UNITED STATES  
NUCLEAR REGULATORY COMMISSION  
WASHINGTON, D.C. 20555-0001

November 9, 2007

SUBJECT: DECISION ON DIFFERING PROFESSIONAL OPINION APPEAL  
INVOLVING RED OIL EVENTS AT THE MIXED-OXIDE FUEL  
FABRICATION FACILITY (DPO-2005-002)

**Figure 3-1. Calorimetry Data Showing Temperature and Pressure Profile for a Typical Mixture of Tributyl Phosphate and Nitric Acid. The Arrow Shows the Inflection Point in Temperature Prior to the Pressure Spike at 162 Minutes (Rudisill and Crooks, 2001).**

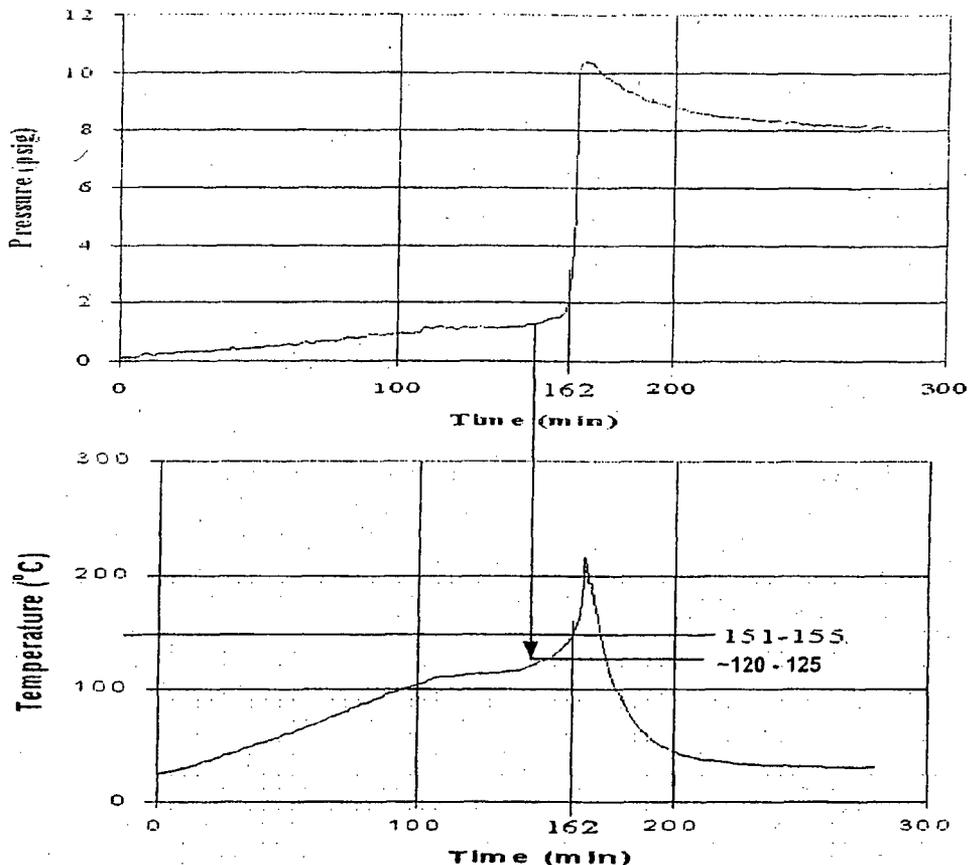
Rudisill and Crooks (2001) examined the red oil runaway reaction temperature. The temperature of runaway reaction was based on the time at which the pressure spike occurred, as shown in Figure 3-1. A detailed examination of the Figure 3-1 indicates that the inflection in temperature (temperature versus time curve) could occur at a much lower temperature {approximately 30 °C [54 °F]} than the pressure spike temperature of 151 °C [304 °F].

Additional tests may be needed to determine the minimum temperature for self-heating. The inflection point indicates a change in the heat generation rate due to self-heating. The temperature at which a pressure spike is observed is indicative of the progression of the red oil runaway reaction. The difference between the temperature at the inflection point and the temperature at which the pressure spike occurs depends on the physical properties of the reactor vessel (e.g., size and insulation). The difference may represent a delay in pressure buildup. If enough time is allowed, the pressure spike may occur at the inflection point. Therefore, the inflection point in the temperature profile where the temperature starts a sharp ascent may be considered as the upper limit beyond which controls would be ineffective, and throttling back to safe condition would be extremely difficult. Paddleford and Fauske (1994) observed the initiation of self-heating in a closed system at 116 °C [241 °F], which supports the
